**MEETING AGENDA
SESSION OF THE HISTORIC PRESERVATION BOARD
CITY OF KISSIMMEE
CITY HALL, COMMISSION CHAMBERS
101 CHURCH STREET, KISSIMMEE, FLORIDA 34741-5054
MONDAY, JANUARY 8, 2024 AT 5:15 PM**

509 Verona Street

New 72-square foot machine room at 509 Verona Street.

1 FRONT ELEVATION
1/4" = 1'-0"

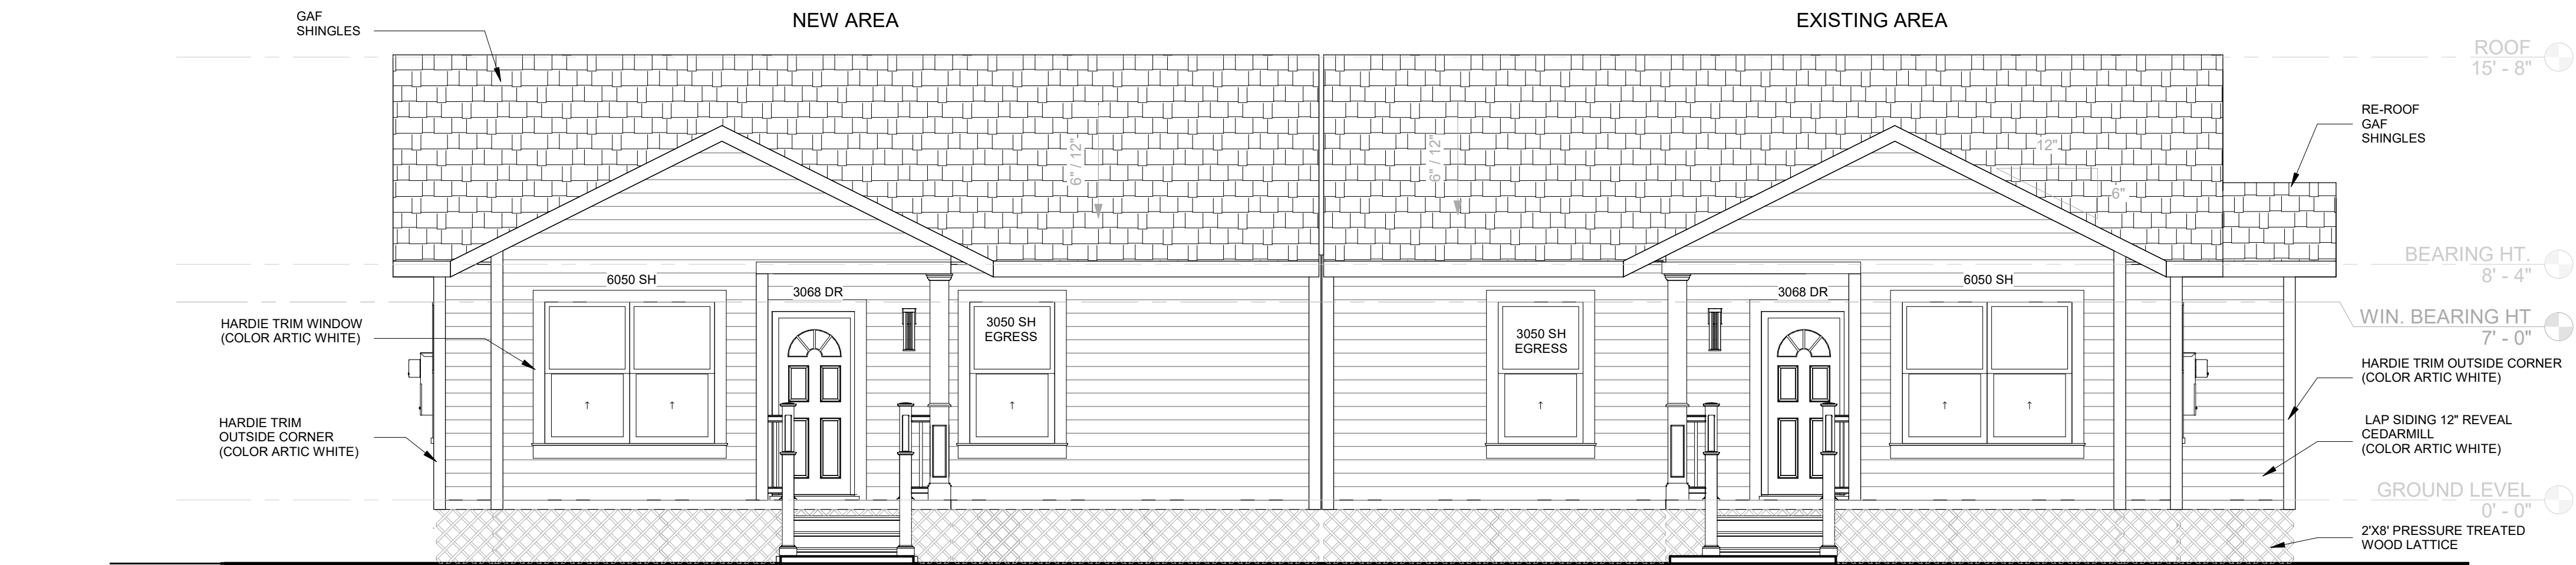
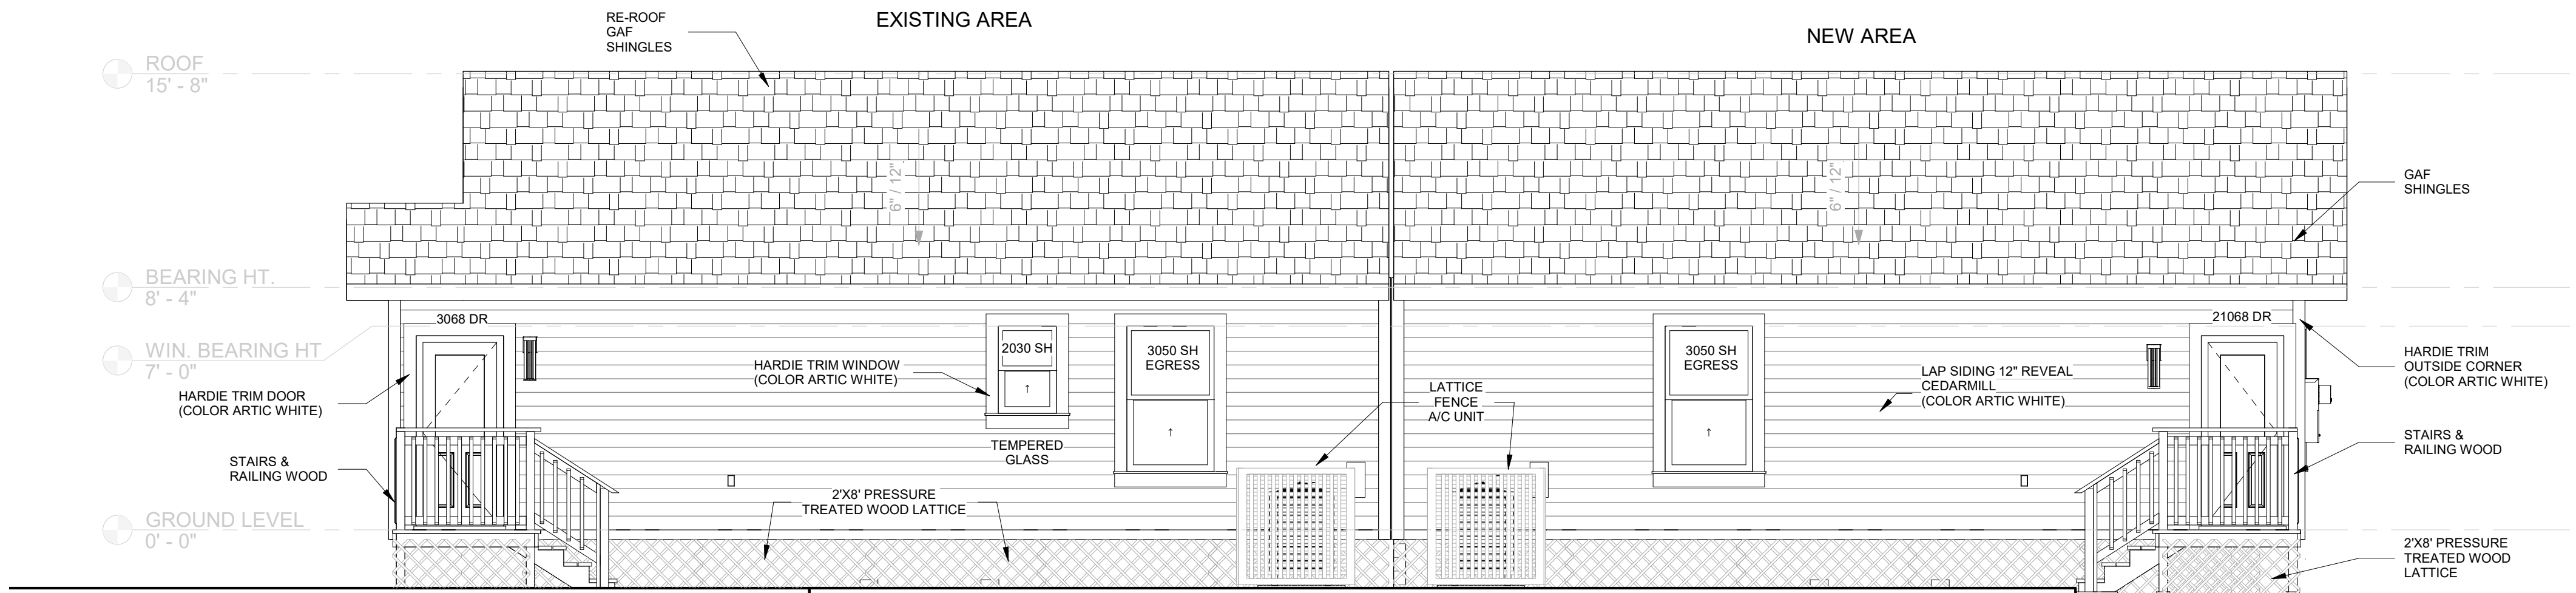
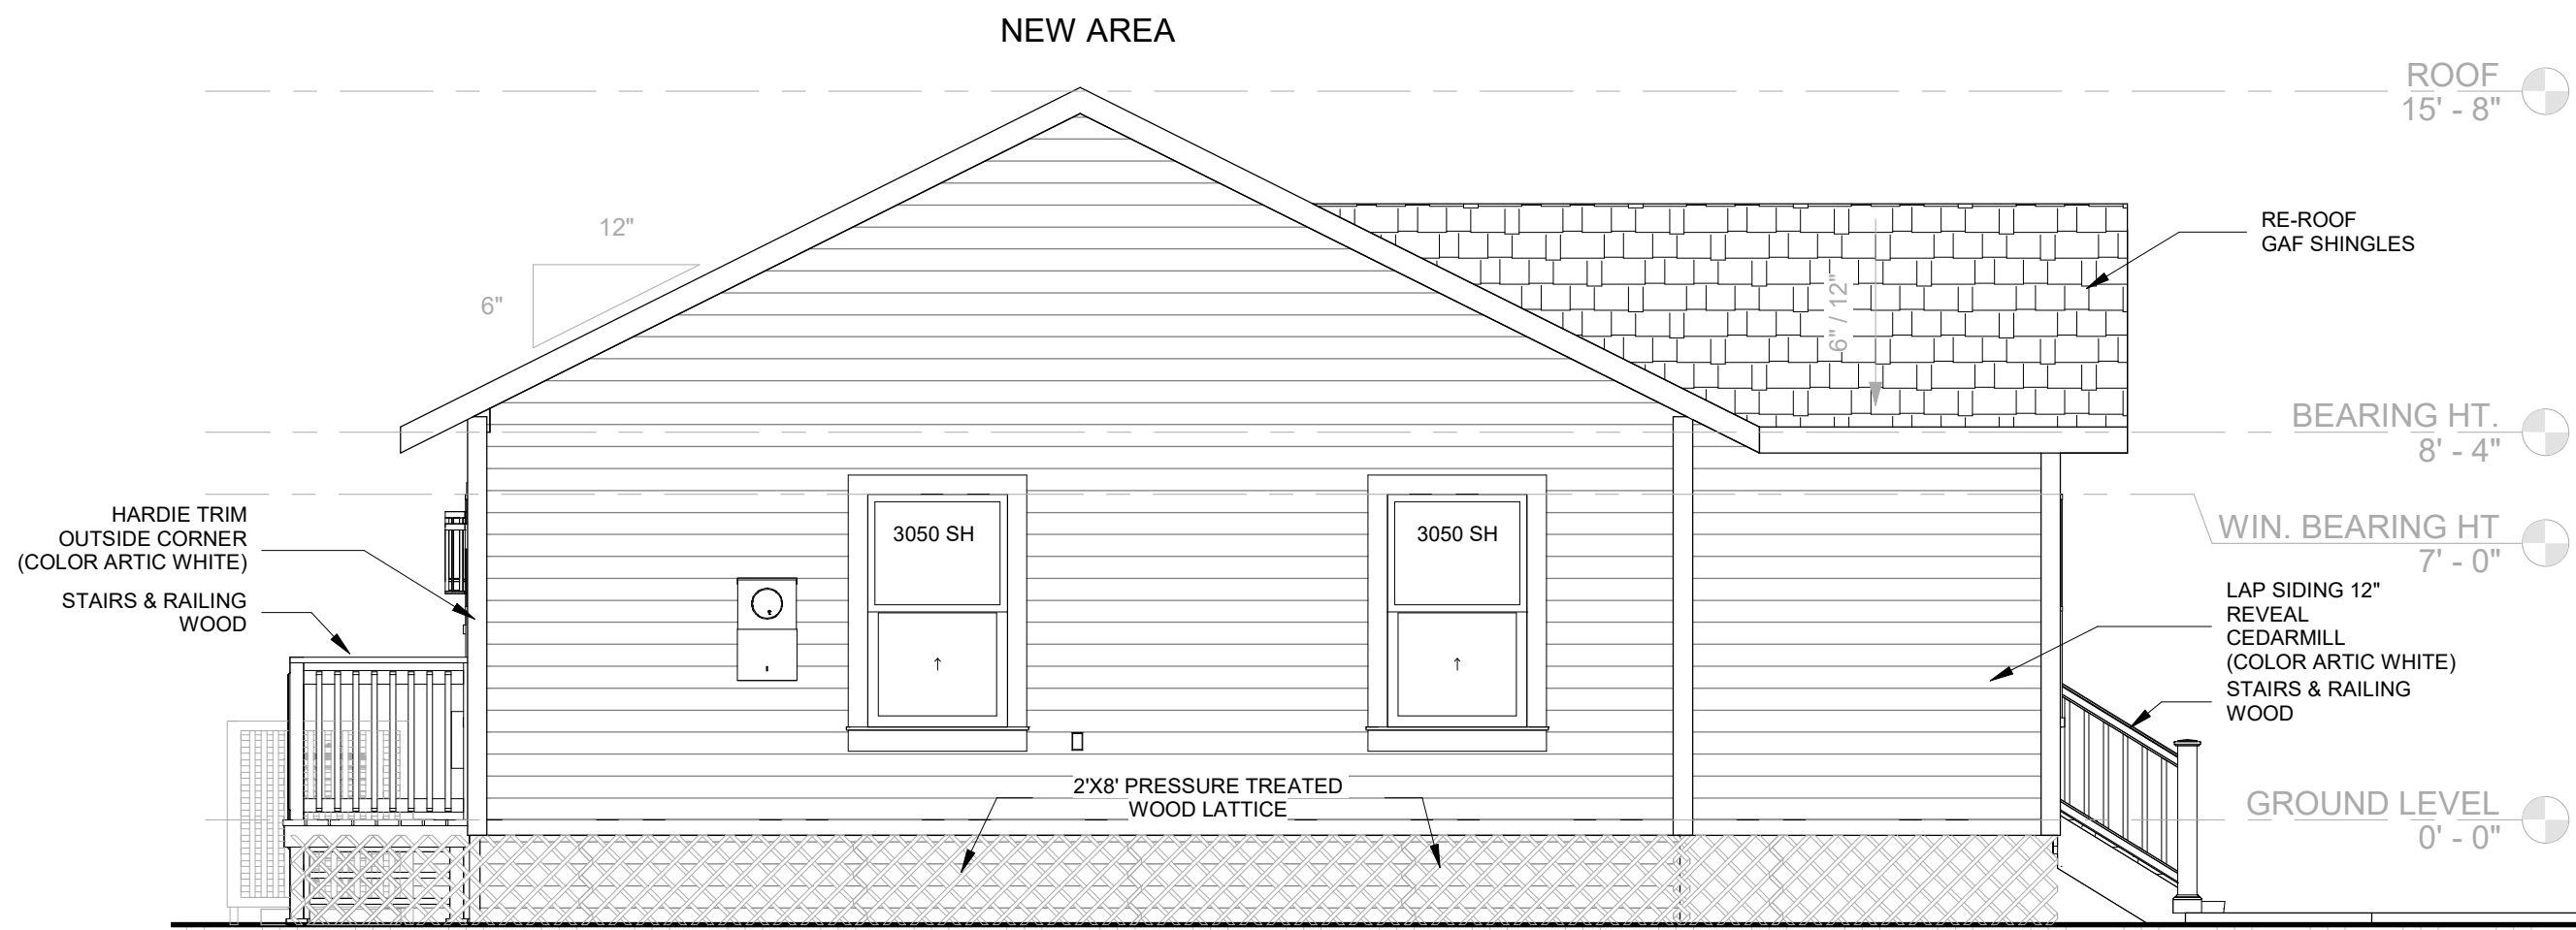
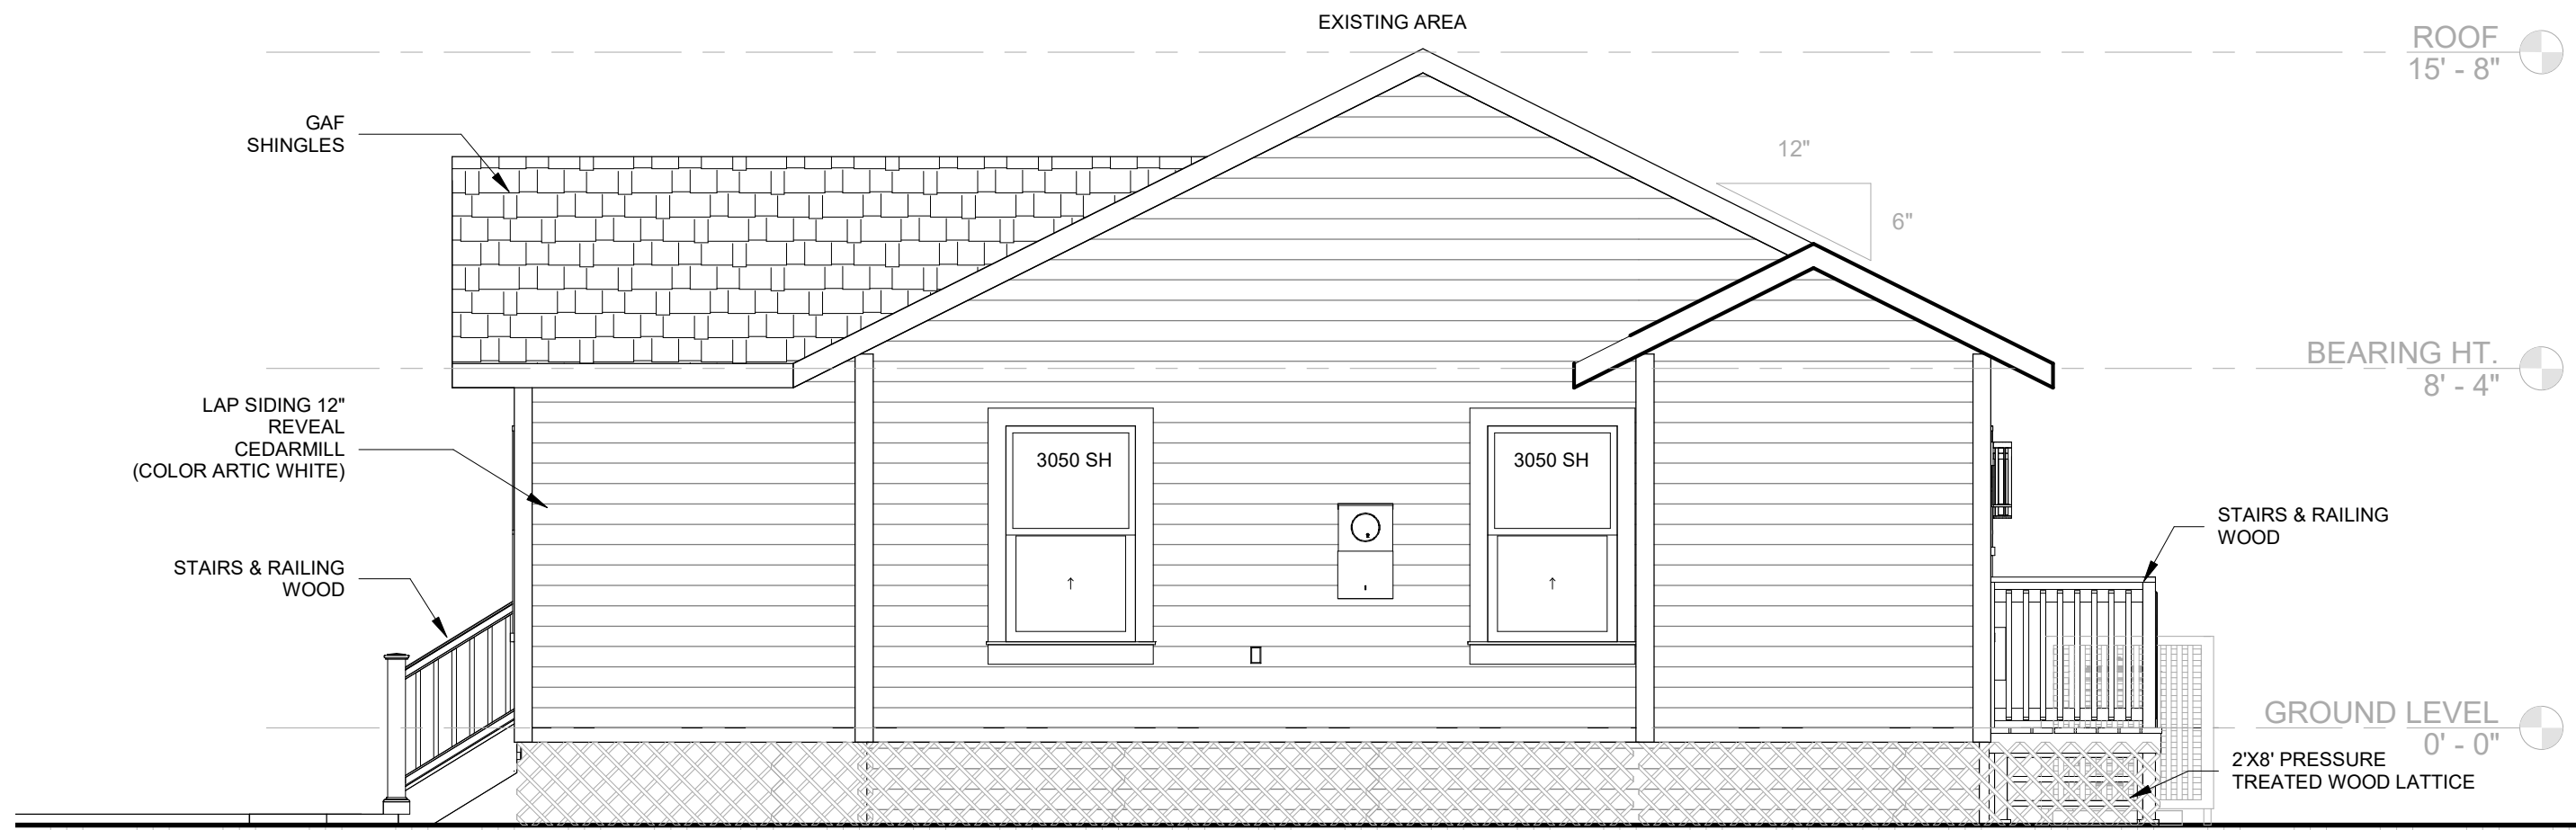
1. The front of the existing structure was reconfigured to add a small porch with the door recessed and off-center. Porches on frame vernacular homes typically span the entire front of the structure and the door is not recessed and centered. Per South Beaumont Historic Preservation guidelines, no porch, balcony or entry may be added to a structure unless compatible with historical, architectural character of the structure.
2. It appears that the front porch was enclosed at some point. An option is to open this area (it could be screened) and restore the porch, which would be consistent with the style and historic guidelines.

2. There is a pressure-treated lattice added to the bottom of the structure. Unless reasonable justification is given, this is not architecturally consistent with the style and should be removed.
